Subject: Duke Energy Carolinas, LLC
Oconee Nuclear Station, Units 1, 2, and 3
Docket Numbers 50-269, 50-270, and 50-287
Request For Additional Information Regarding Proposed License Amendment Request
for Methodology Report DPC-NE-1006-P, "Oconee Nuclear Design Methodology Using
CASMO-4 / SIMULATE-3"
License Amendment Request No. 2009-02

REQUEST FOR ADDITIONAL INFORMATION

DPC-NE-1006-P

Oconee Nuclear Design Methodology Using CASMO-4 / SIMULATE-3

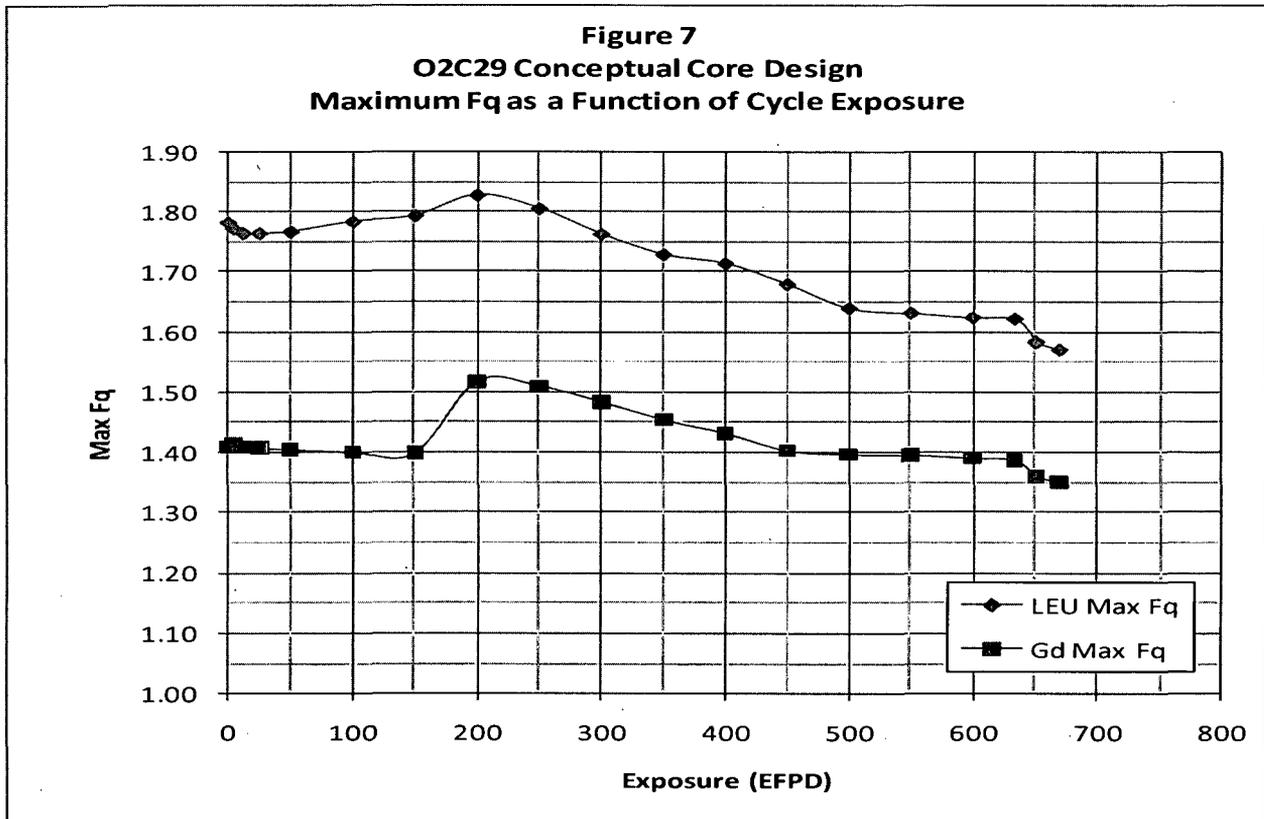
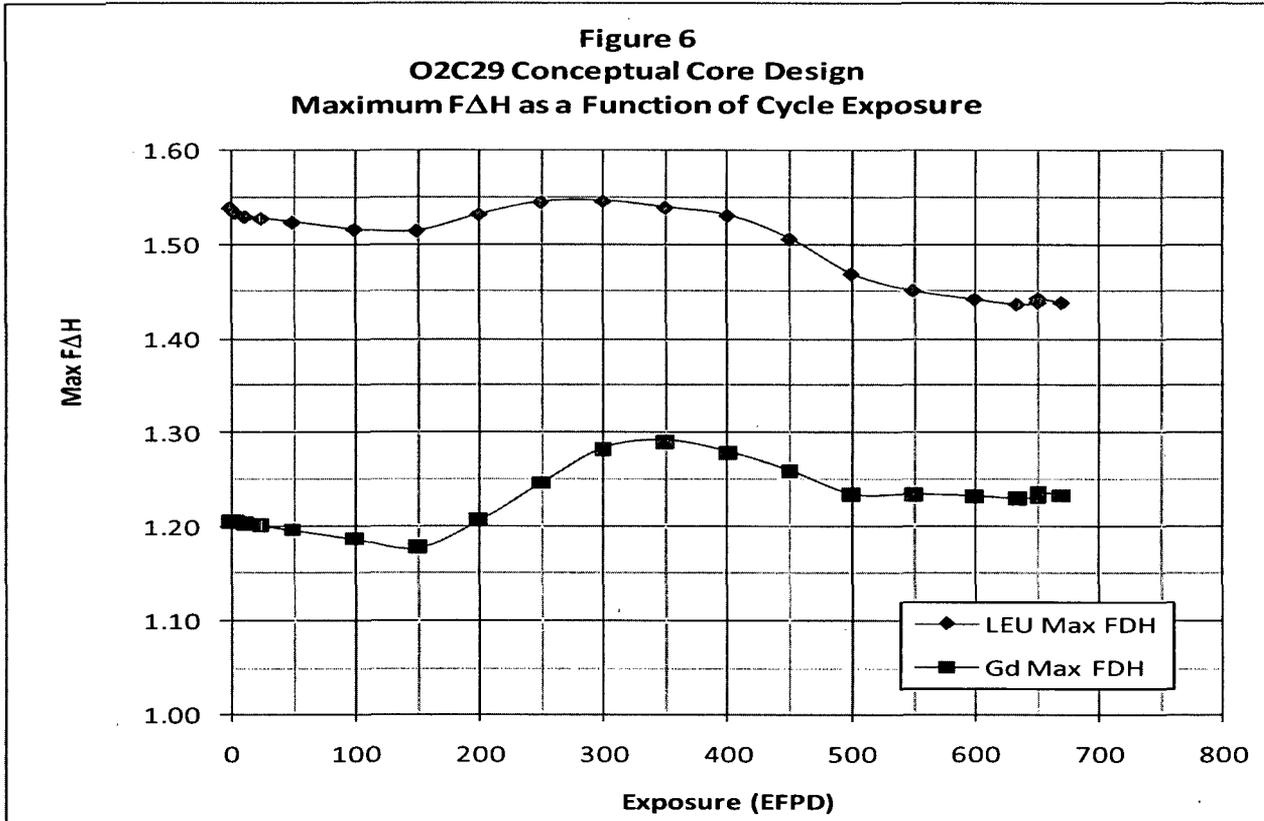
- Q2:**
- a) Page B1-2, paragraph 2 states that due to the diverse core designs used in the Sequoyah benchmarking, the results are considered applicable to future McGuire and Catawba core designs. Please provide details on the gadolinia concentrations and fuel assembly designs planned for upcoming McGuire and Catawba core designs.
- b) If available, please provide the calculated results for the upcoming McGuire and Catawba core designs. Please include calculations of assembly average power distributions, LEU and gadolinia pin power distributions, power distribution peaking factors, and the statistical variance of the power distribution results. The predicted power for the gadolinia pins should be calculated after the gadolinia is depleted, as this is when the gadolinia pin power may become limiting.

Figures 2 through 5 present the SIMULATE-3 calculated core radial power distributions and limiting pin power details for burnups of 4, 200, 400 and 670 EFPD. Assembly average powers, peak integrated pin powers ($F\Delta H$) and the peak pin powers (Fq) are presented. Figures 6 and 7 show core peak integrated pin powers and peak pin powers at nominal HFP conditions as a function of burnup for both UO_2 (LEU) and $UO_2+Gd_2O_3$ (GAD) fuel pins. As indicated by the data, the GAD fuel pins never exceed the LEU power density.

LEU and GAD fuel pin power distributions for core locations K-12 and K-14 are presented at burnups of 4, 200, 400 and 670 EFPD in Figures 8 through 15. Sample pin power distributions for core location K-12 are presented in Figures 8 through 11 and were chosen because this core location exhibited the highest integrated power density ($F\Delta H$) of feed fuel locations early in cycle. Sample pin power distributions for core location K-14 are presented in Figures 12 through 15 and were chosen for presentation because this core location exhibited the highest Fq of feed fuel locations early in cycle.
